To: Shin-Roei Lee
From: A.L. Riley
Setenay Frucht
cc: memo to file
Date: June 13, 2014

Subject: Review of modeling received on June 6 and related questions – *SFCJPA Responses in Red*

We have reviewed the modeling for Alternatives 1-4 from June 5, 2014 deliverable, as well as Alternative (Alt) 4+ provided by HDR on June 6, 2014.

FIGURE 1

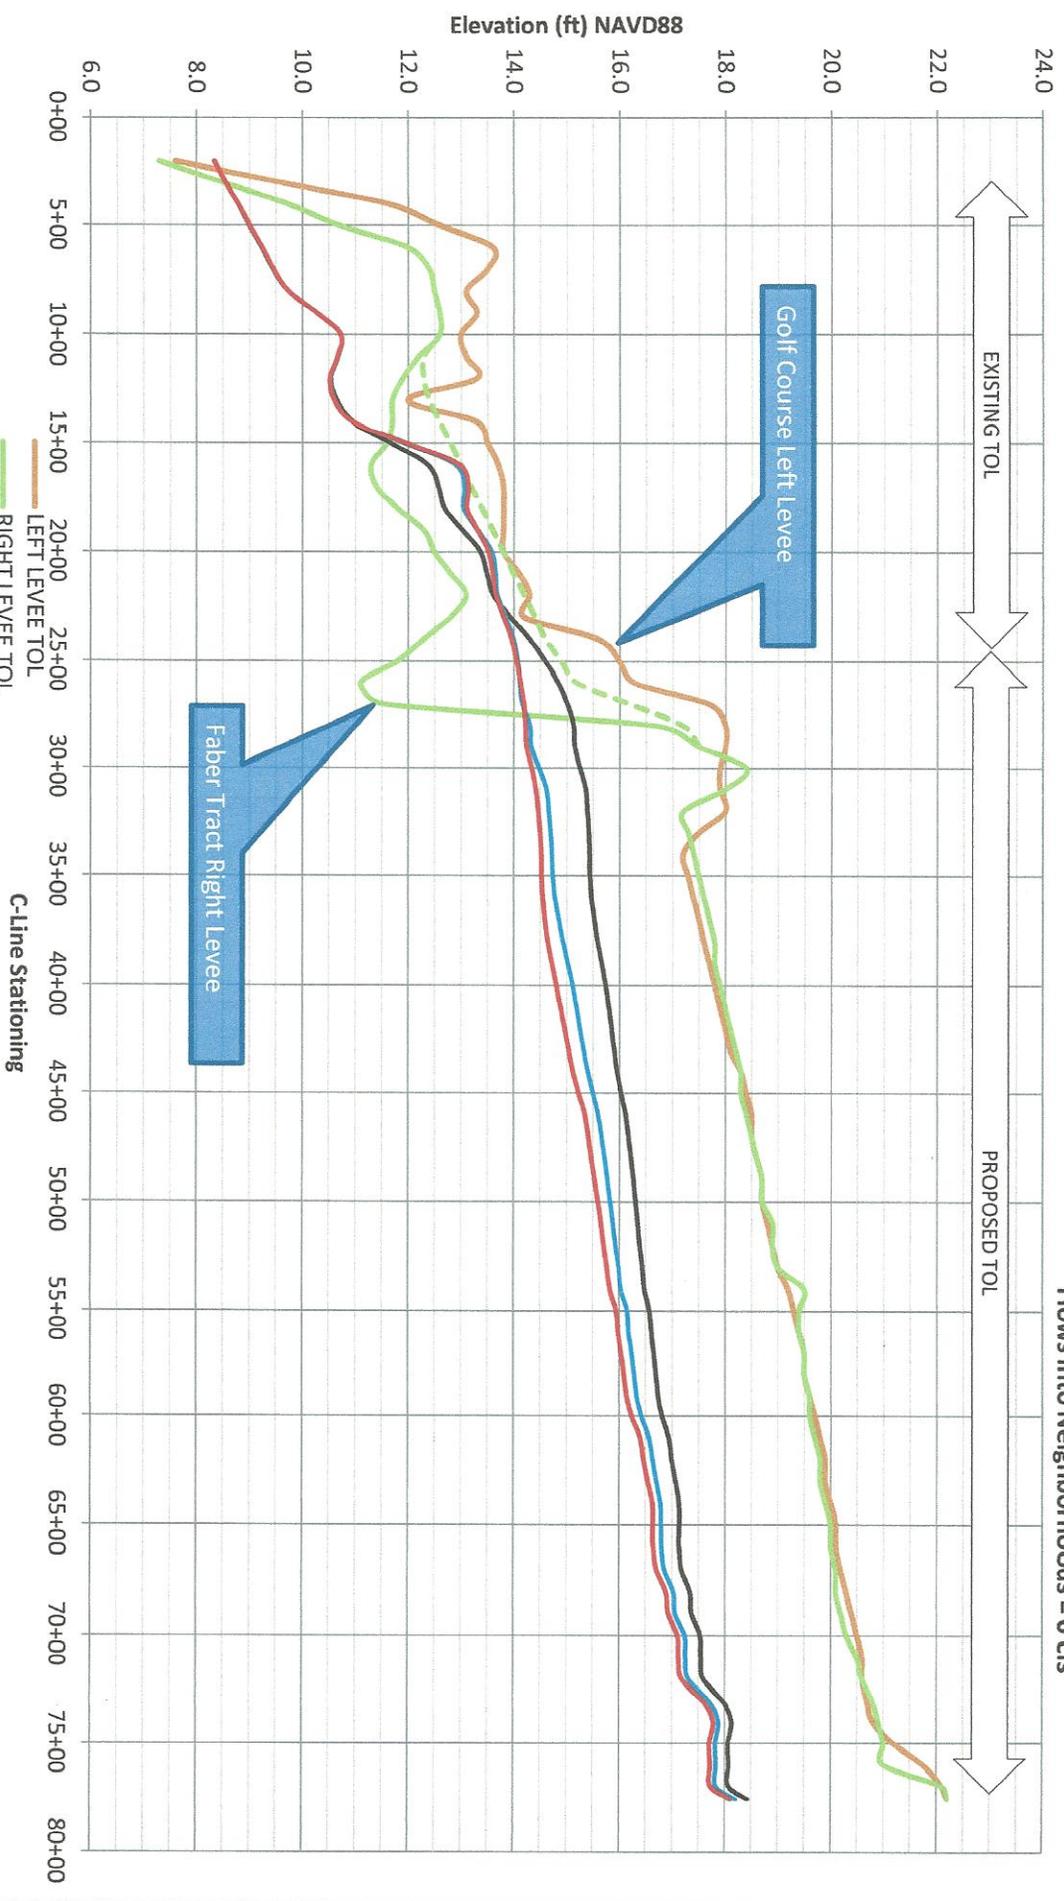
When evaluating WSE profiles from the June 6 HEC-RAS model, there are limited water surface elevation benefits for Alt 4 (larger setback)—a 1 foot decrease around the Friendship Bridge—and the benefits gradually decrease as you travel upstream towards Hwy 101. Alt 4 (larger setback) does cause a WSE increase adjacent to the downstream lowest spot in the Faber Tract levee when compared to Alts 2 and 3. This rise is due to the severe pinching in of the channel back down to the existing channel width near station 14+00. See Figure 1 profile for results for Alts 2, 3, and 4 at 9,400 cfs at 7.1' as requested by RWQCB staff.

The SF Bay levee degrade and setting back the levees have a benefit throughout the entire reach except for a hydraulic jump at about 800 to 1,400 feet from the mouth of the San Francisquito Creek (see Attachment A). The model indicates that degrading the SF Bay levee is causing this hydraulic jump, not setting back the levee. One question is how do we smooth out the hydraulic jump at this location by running the model in the downstream area with a different regime of flow types (e.g., mixed flow as opposed to subcritical flow)?

The above statement is not correct. The model results (see Figure 1) do show that both Alt 3 (large setback) and Alt 4 (larger setback) cause the water surface increase, decrease, and increase due to sudden expansion and contraction from the proposed setback alignments, however, a hydraulic jump is not occurring. This can be verified by looking at the results of the HEC-RAS model, especially the Froude number, which remains below 1.0. The sudden cross section contraction caused WSE to rise and therefore cause the velocities to increase. Once flow gets past the contracted section, the water expands back out and velocities decrease causing the WSE to rise again. The current 95% design has a longer transition back to the existing levee alignment and thus has less short-term effects on the WSE. In order to potentially smooth out the varying WSEs, the setback alignment would need to begin transitioning back to the existing alignment farther upstream of station 14+00. This is an iterative process that is usually completed as part of development of the design. Changing the modeling method would not change the water surface profile results.
